United States Patent and Trademark Office

| APPLICATION NO. | FI | LING DATE | FIRST NAMED INVENTOR | ATTORNEY DOCKET NO. | CONFIRMATION NO. | |
|-----------------|-----------------|---------------|----------------------|---------------------|------------------|--|
| 10/540,143 | 06/21/2005 | | Makoto Katsumata | 050396 | 3589 | |

| | | | A |
|--|--|---|---|
| Office Action Summary | Examiner | Art Unit | |

DETAILED ACTION

IG. 9B

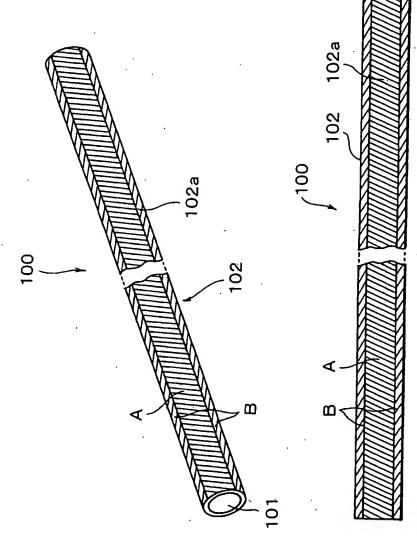
cable (Fig 11) with regular intervals (Fig 9b & 11, both shown the ink deposit nozzles being on opposite sides with respect to a circumferential direction) and wherein the first and second outer surfaces (outer surfaces of the left and right ends) are provided with a plurality of first and second marks (M1 & M2, respectively) that are alternately positioned (Fig 9b).
